# VOLLMER ROAD (BARBARICK) - INTERIM CONDITION

### STREET IMPROVEMENT PLAN

#### JULY 2023

VOLLMER ROAD (BARBARICK)  
- INTERIM CONDITION  
COVER SHEET

**VOLLMER ROAD (INTERIM BARBARICK SECTION)  
MODIFIED RURAL MINOR ARTERIAL CROSS SECTION**  
SCALE: NTS

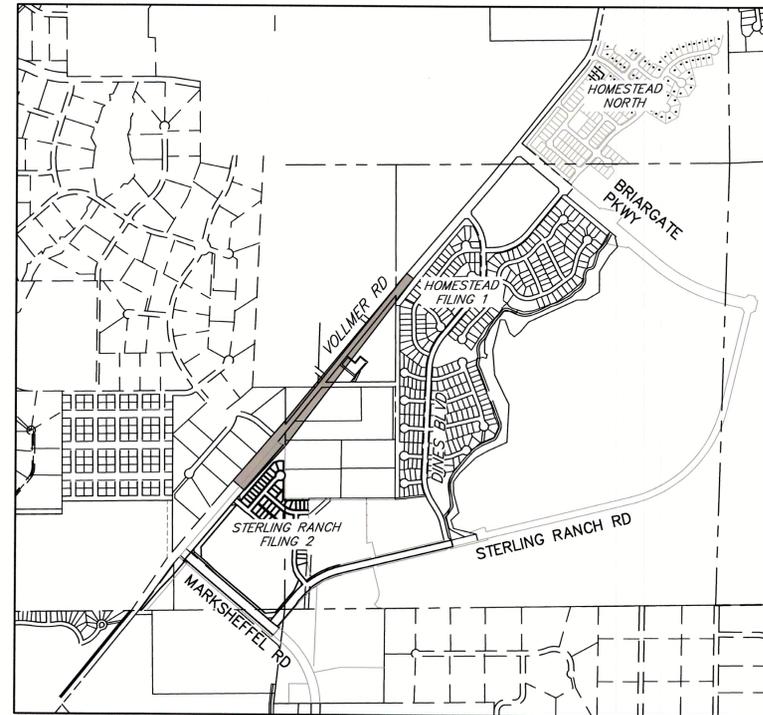
The interim cross section should show the existing roadway and the proposed widening section clearly distinguished.

JR Response: the existing road section varies in width and in location as compared to the proposed section. Existing road label added to interim cross section
